# 1321-25 N 5th St

CIVIC DESIGN REVIEW

Date: 2024.03.05

Please see our responses below, in red.

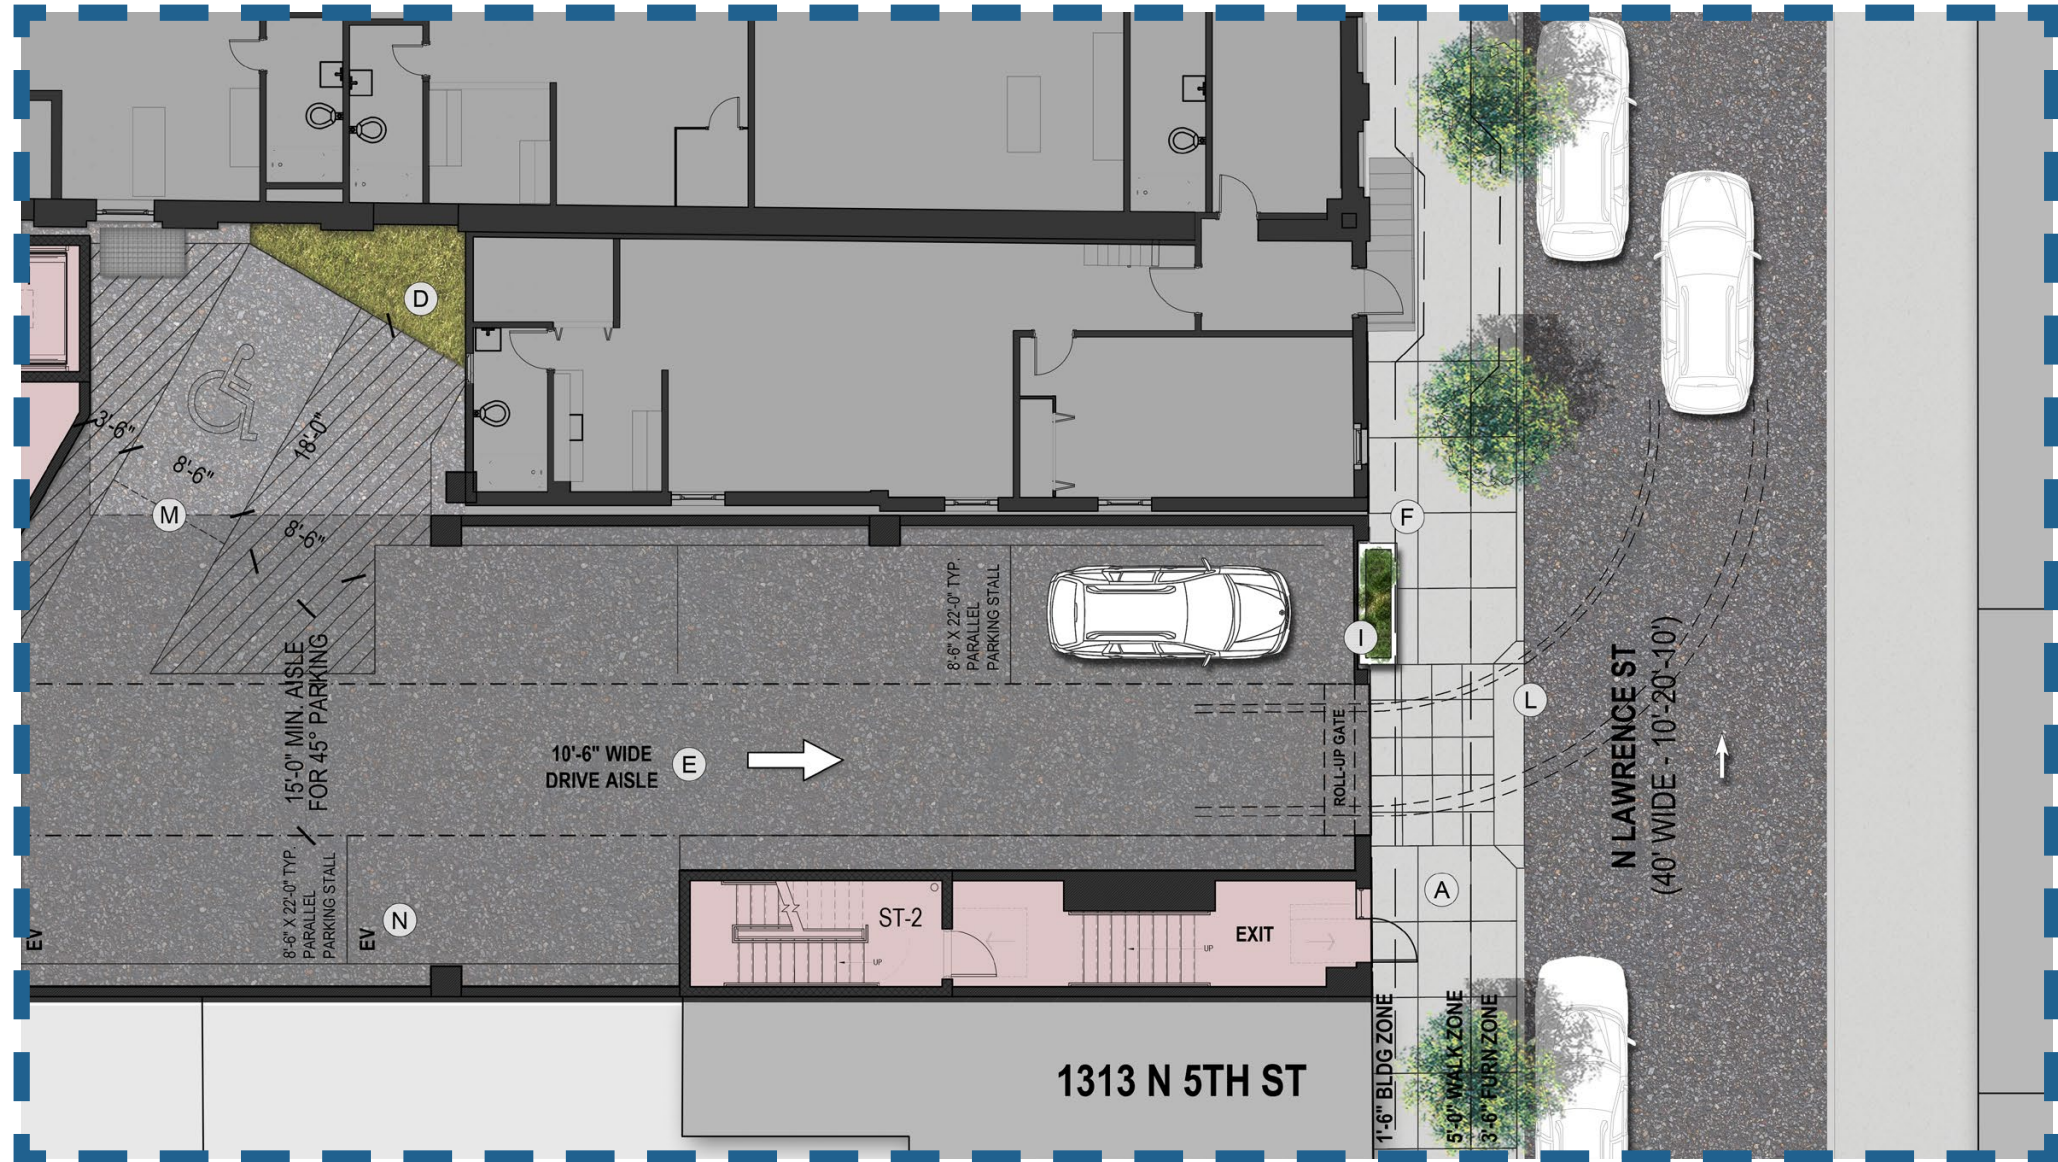
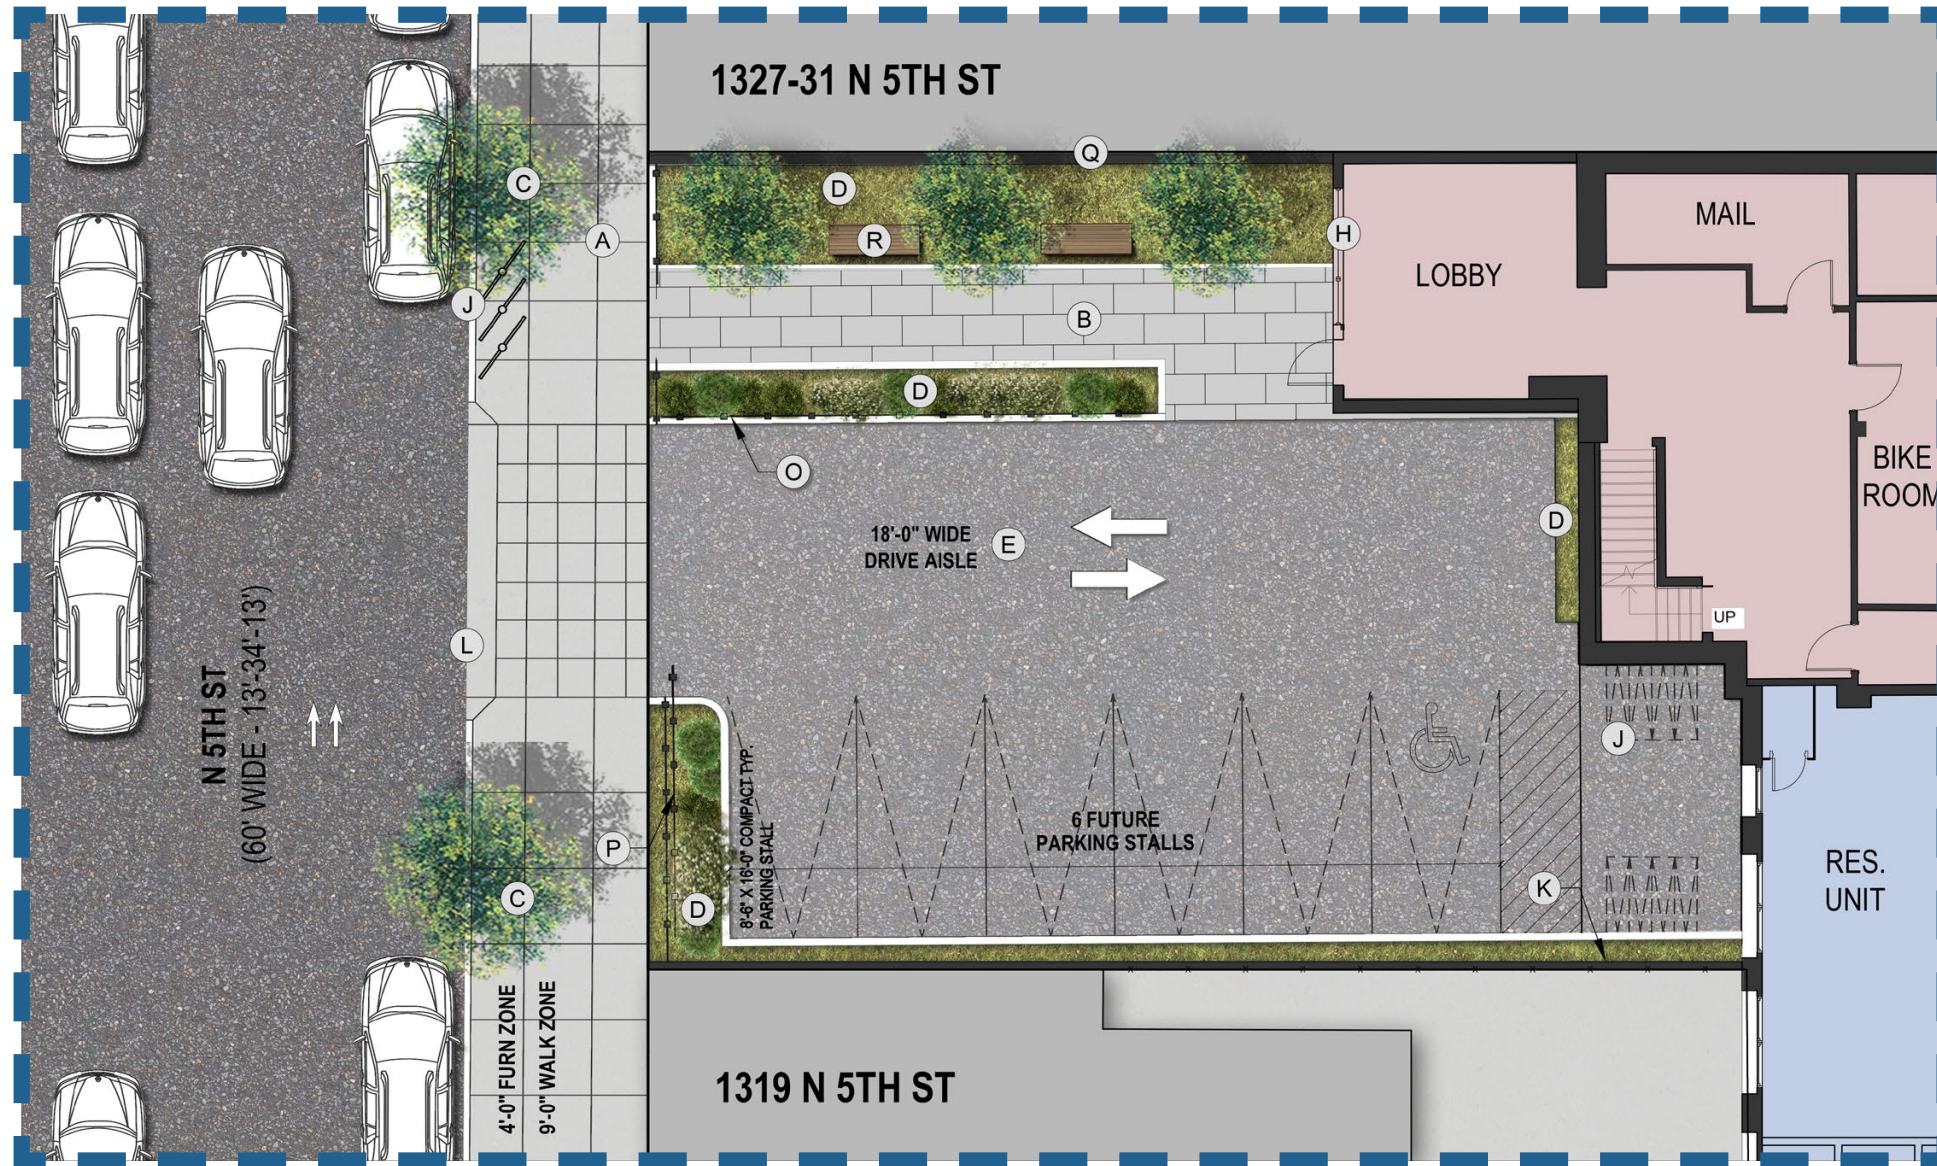
Consider addition of more street trees and planters around the site to create a more

The pool area will be in shadow for most of the year. We are working with existing conditions. The courtyard has a charming, industrial aesthetic which should be utilized as a residential amenity space to activate the site. The pool area receives sunlight in the AM and early afternoon. A heated pool has been discussed to combat this issue.

desirable pedestrian experience. The N. 5th street courtyard revisions address this to some extent. We have provided planters along the frontages of our addition, as well as provided streets trees in all approvable locations.

**Ground Floor Plan**

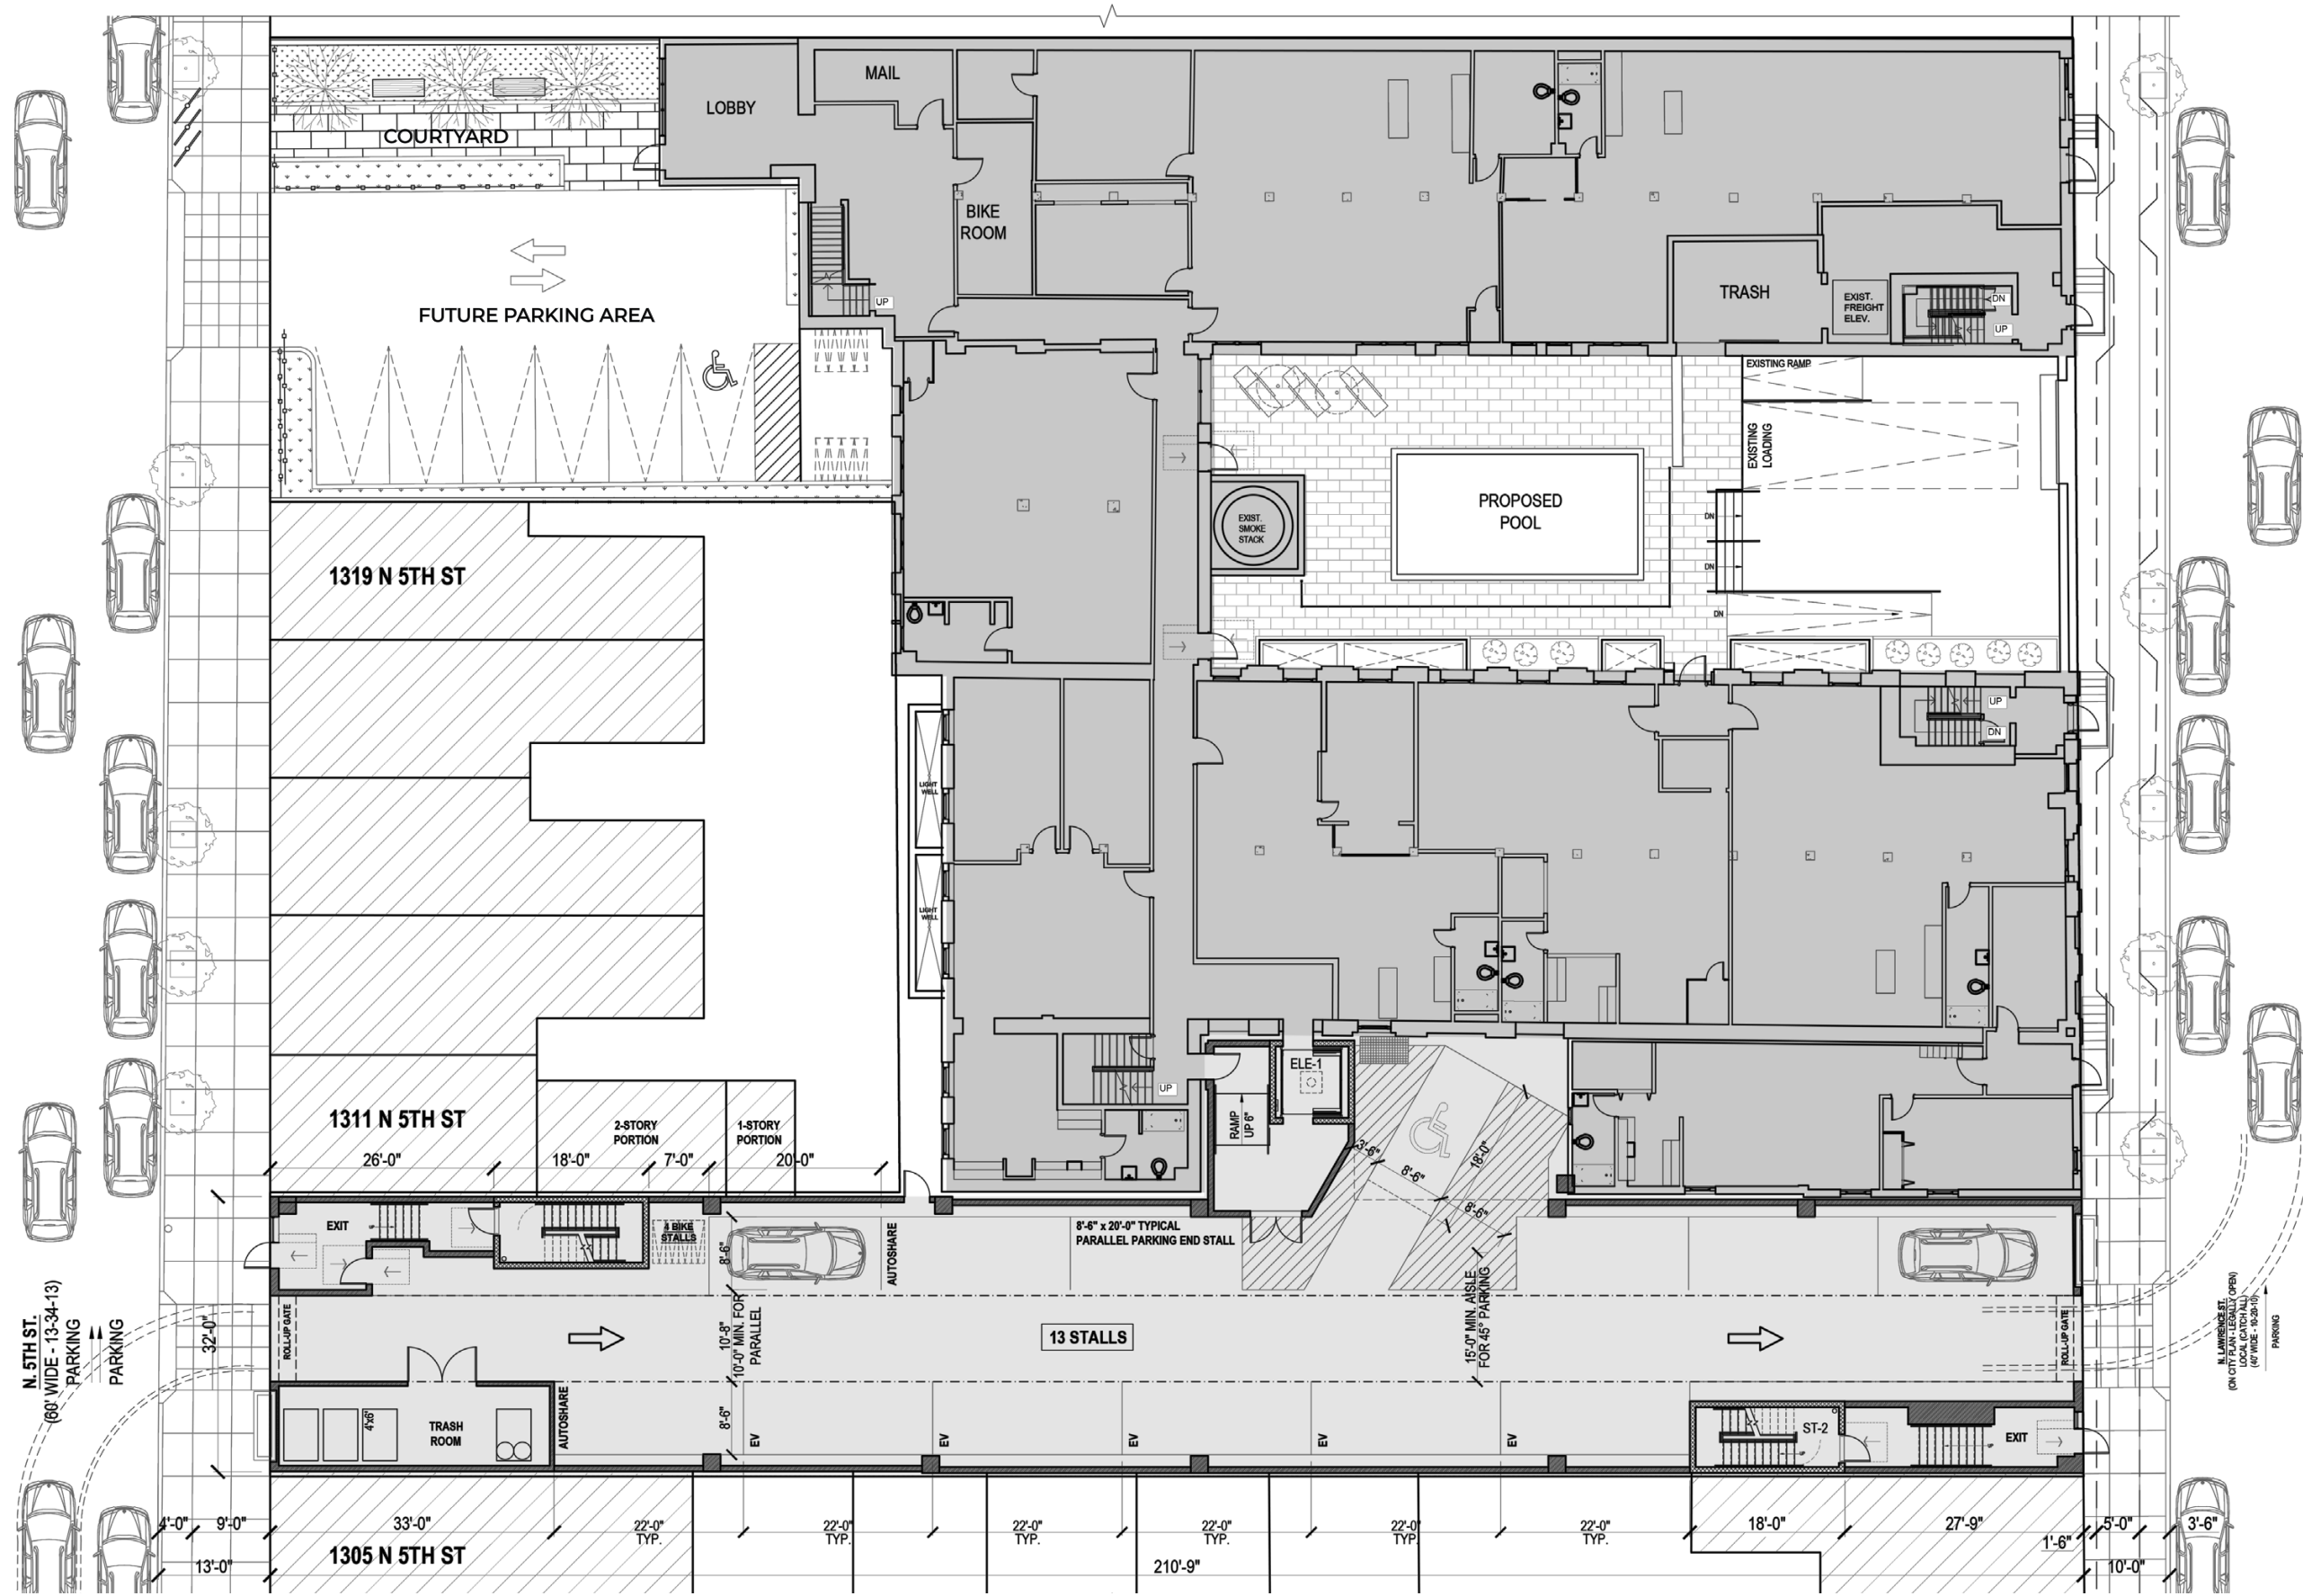
Committee and staff were concerned about the lack of a prominent residential entrance and lobby space. Paths to the units and the elevator were less than ideal, especially for someone with a disability. Most of the ground floor was dedicated to inactive uses and blank walls. It was suggested that a more prominent and welcoming entrance to the building closer to the elevator be provided. This has been addressed with the revisions to the N. 5th street entrance. The location of the elevator is a result of existing conditions and is located in a practical location that services all building functions.

It was recommended that courtyards be activated, the blank walls be opened up (especially along N 5th Street for the building to be more integrated into the neighborhood). Also, the Committee noted that it was important for them to know what the intentions would be for this courtyard. This has been addressed in the revisions to the N. 5th St. courtyard area. The cmu wall along N. Lawrence street has been maintained as the client feels this contributes to the industrial character of the building.
